SUBJECT: Application for amends to Licenses DPR-58 & DPR-74, modifying  
 Tech Spec Table 3.3-3. Fee paid.

Donald C. Cook Nuclear Plant Units 1 and 2  
Docket Nos. 50-315 and 50-316  
License Nos. DPR-58 and DPR-74  
TECHNICAL SPECIFICATION CHANGE:  
MOTOR-DRIVEN AUXILIARY FEEDWATER ACTUATION SIGNALS

Attachment 1 to AEP:NRC:1030A  
Reasons and 10 CFR 50.92 Analyses for Changes to the  
Donald C. Cook Nuclear Plant  
Units 1 and 2 Technical Specifications

Figure 1 Donald C. Cook Nuclear Plant auxiliary feedwater system

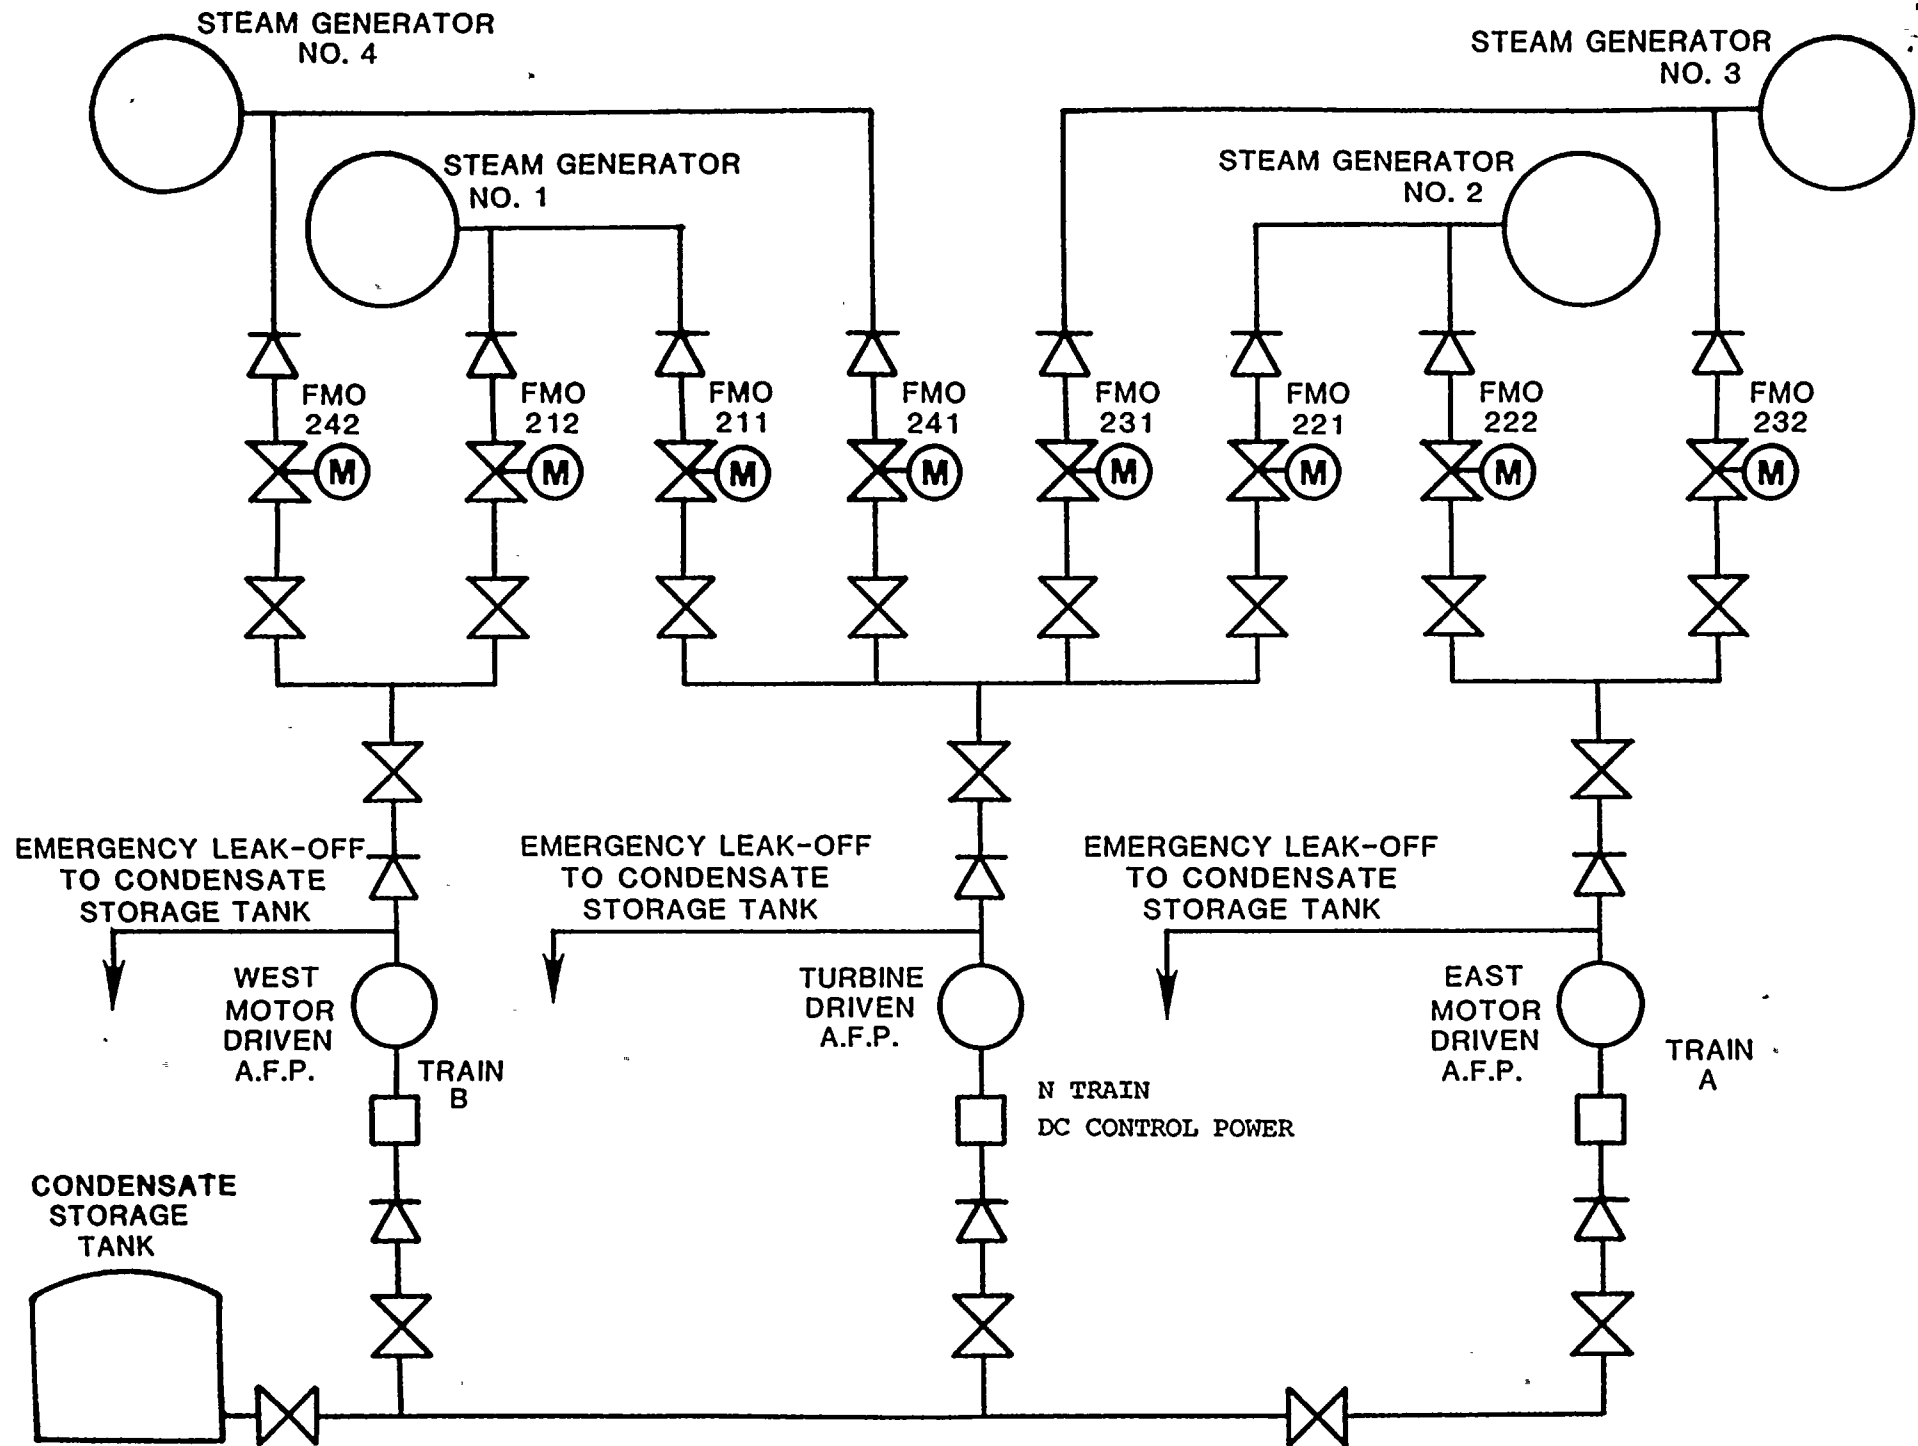
A schematic drawing of the motor driven auxiliary feedwater pump system at the Cook Nuclear Plant is presented in Figure 1 of this attachment. As indicated in the figure, the Train A (East) pump delivers flow to Steam Generator No. 2 via motor operated valve FMO-222, and to steam generator No. 3 via FMO-232. Likewise, the Train B (West) pump delivers flow to steam generator No. 1 via FMO-212, and to steam generator No. 4 via FMO-242.

**Figure 2 Power sources for motor driven auxiliary feedwater pumps and associated valves**

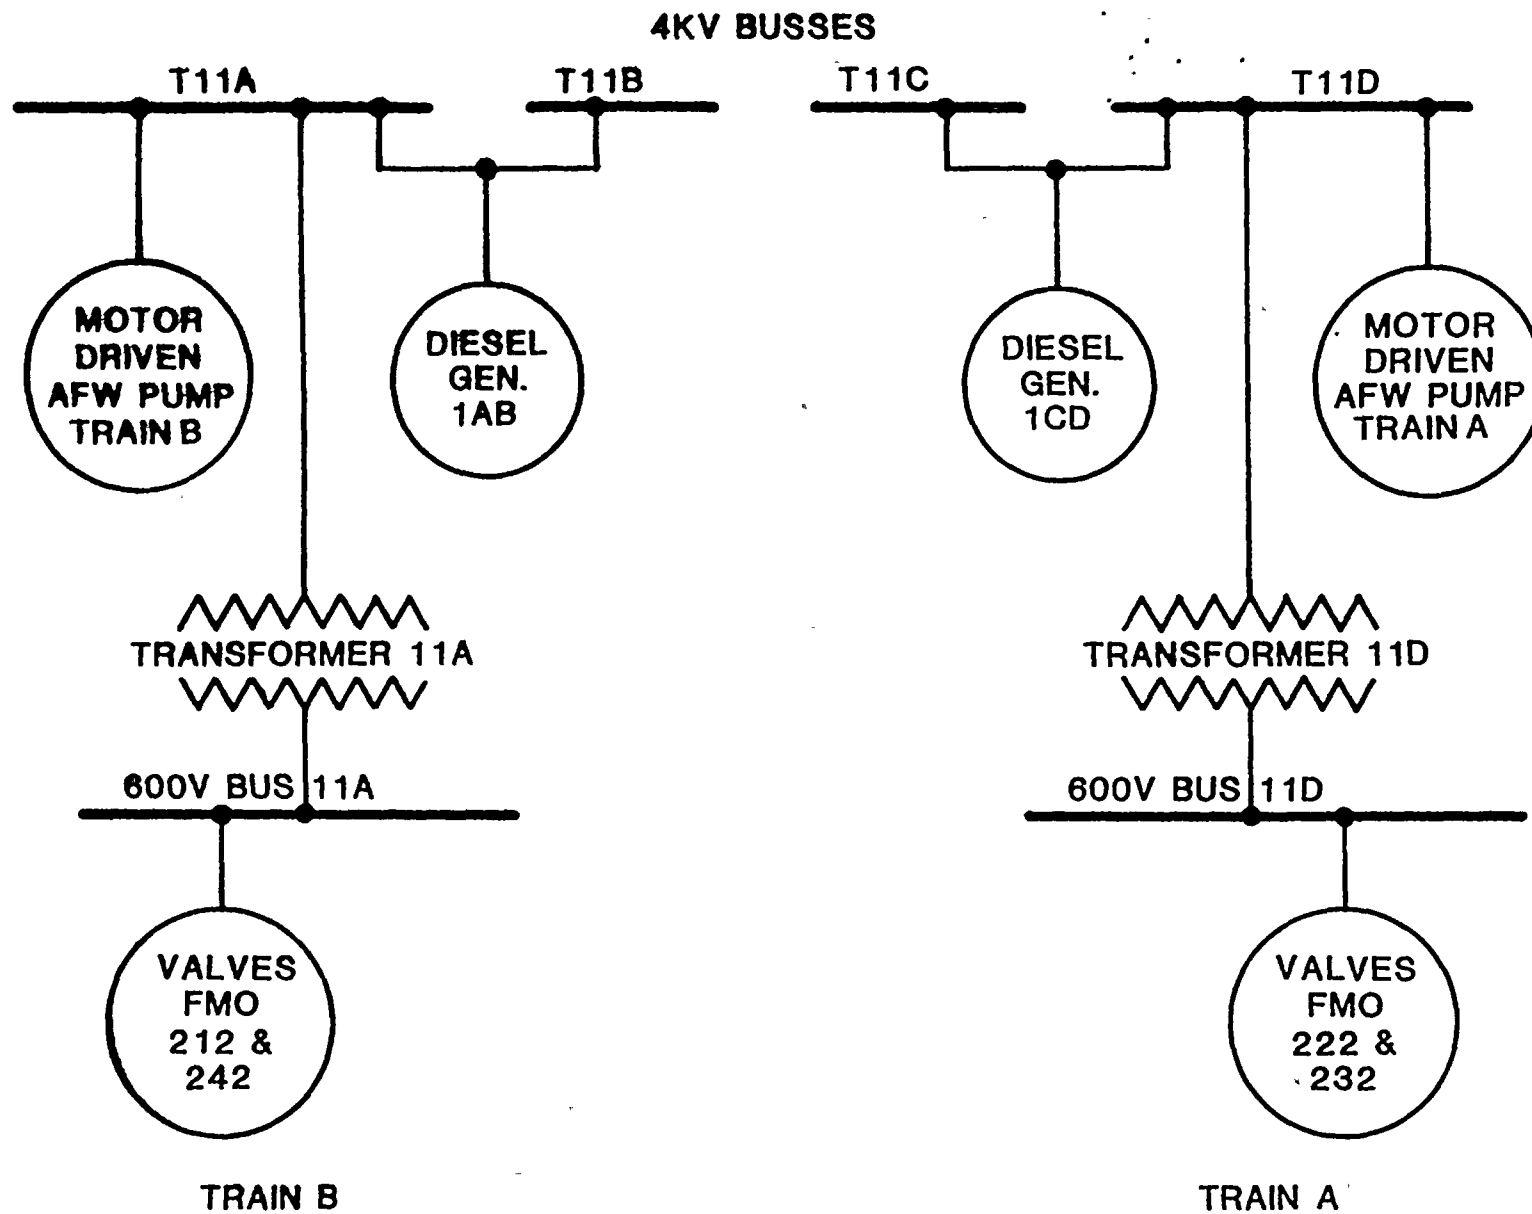
A schematic drawing of the electrical bus arrangement with regard to the motor driven auxiliary feedwater pumps and their associated motor operated valves is provided as Figure 2. As indicated in the figure, the Train B pump is powered from the 4kv bus T11A. The valves associated with the Train B pump are powered from the 600-volt bus 11A, which is fed from bus T11A. The Train A pump and valves are similarly fed from 4kv bus T11D and 600-volt bus 11D, respectively.

There are 3 relays (channels) which indicate loss of voltage on each of the 4 safety busses. Actuation of 2 of the relays on bus T11A will start an emergency diesel generator and the Train B motor driven auxiliary feedwater pump. Similarly, actuation of 2 of the relays on bus T11D will start an emergency diesel generator and the Train A pump.

T/S Table 3.3-3 Functional Unit 6.b as currently written states that there are a total of 2 channels per bus, with both channels

per bus required to trip. The functional unit as written is incorrect since, as described above, there are actually 3 channels per bus. Furthermore, it is misleading in that it does not indicate that loss of voltage on two busses is necessary to open the FMO valves. For these reasons, we are proposing to modify the functional unit as indicated below.

<u>Functional Unit</u>	<u>Total No. of Channels</u>	<u>Channels to Trip</u>
b. 4kv Bus loss of voltage	3/bus	
Pump start		2/bus (T11A-Train B; T11D-Train A)
Valve Actuation (Both trains)		2/bus on (T11A & T11B or 2 busses T11C & T11D)
